Recall Campaign Bulletin

Campaign No. 2022080010, September 2022

SUBJECT: **Various Models**
Model Year 2019-2022

Check Transmission Wiring Harness Connector

Figure 3

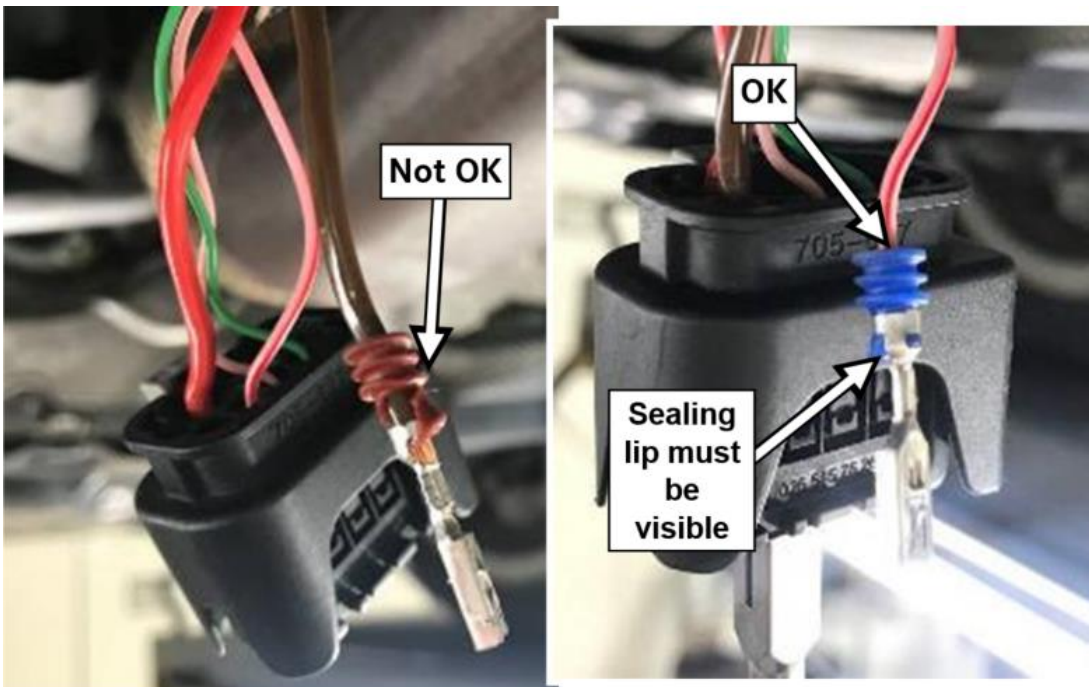
4. Check pins from the **vehicle side** wiring harness (B, figure 2) with the special tool **W 220 589 01 99 63** (figure 3). **Unpin** each individually, check for corrosion and damage such as wire melting or wire sealing lips (figure 4), **and then pin back in**. DO NOT remove all pins at once.

- i** Equivalent commercially available unpinning tools can be used.
- i** **All pins may not** be unpinned from the plug housing **simultaneously**.
- i** The **pins must audibly engage** when reinserted.
- i** No damage or noticeable problems may be visible.
- i** No sealing elements may be damaged or melted at the cables.
- i** Sealing elements must be properly crimped in the cable lug.
- i** See OK figure. Sealing lip must be visible.
- i** Figure 4 shows a *not OK* and OK sealing element!

Figure 5

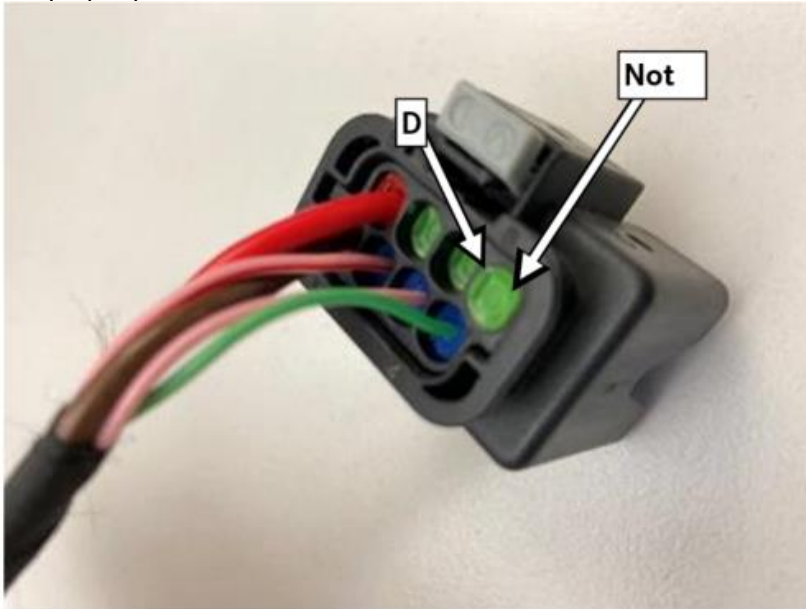
5. Check green blind plugs (D, figure 5) on the rear side of the connector for proper seating, rework if necessary.

i If the connector and the blind plug has no damage and are out of place, the blind plugs need to be pressed into its proper position.

Figure 6

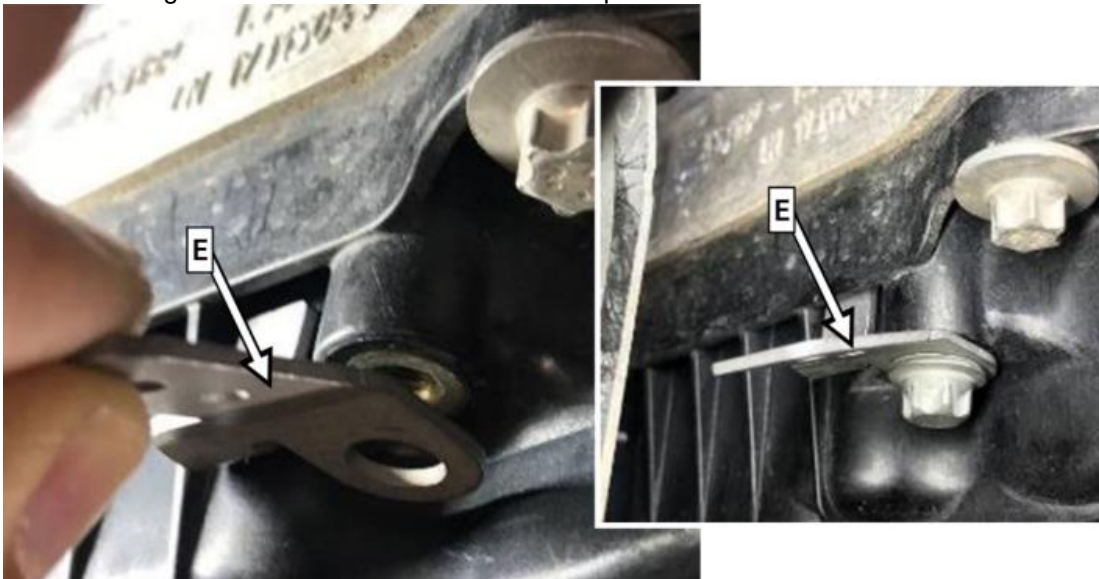
1. Attach new additional wiring harness bracket (E, figure 6) with new screw to transmission oil pan.

i Threaded bushing is already present in the oil pan.

Nm Wiring harness bracket to transmission oil pan **8 Nm**.

Figure 7

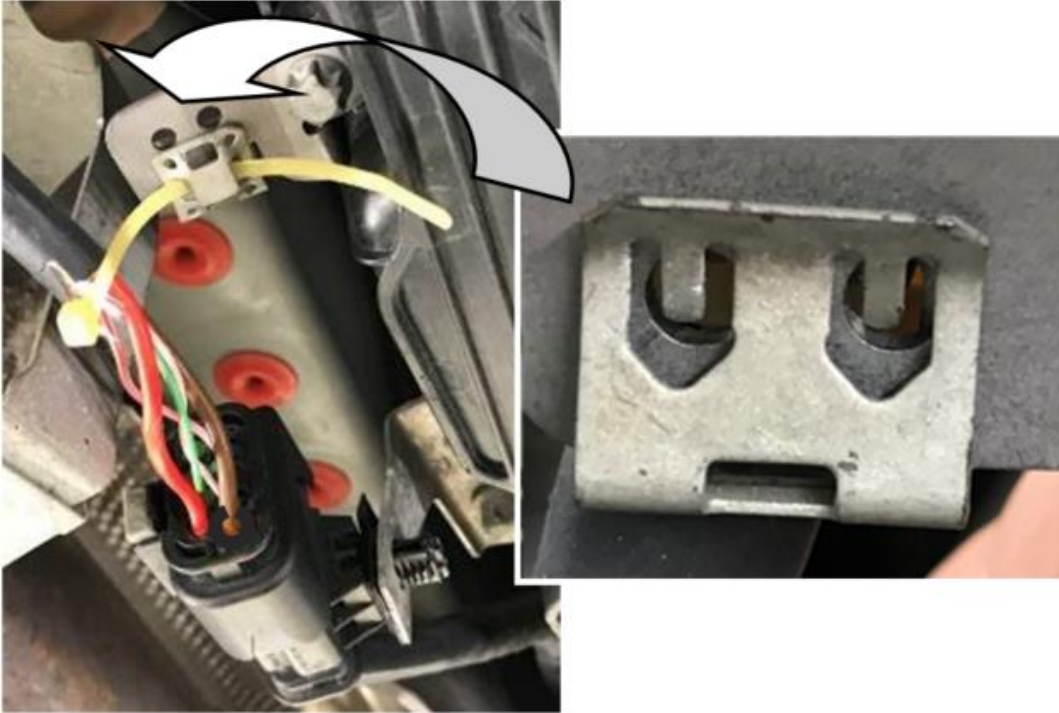
2. Remove retaining clamp and cable tie from the vehicle-side wiring harness.
3. Attach retaining clamp with **new** cable tie (figure 7) to new wiring harness bracket in direction of travel from rear up to end stop.

i Retaining lugs of the retaining clamp engage in the bores of the bracket.
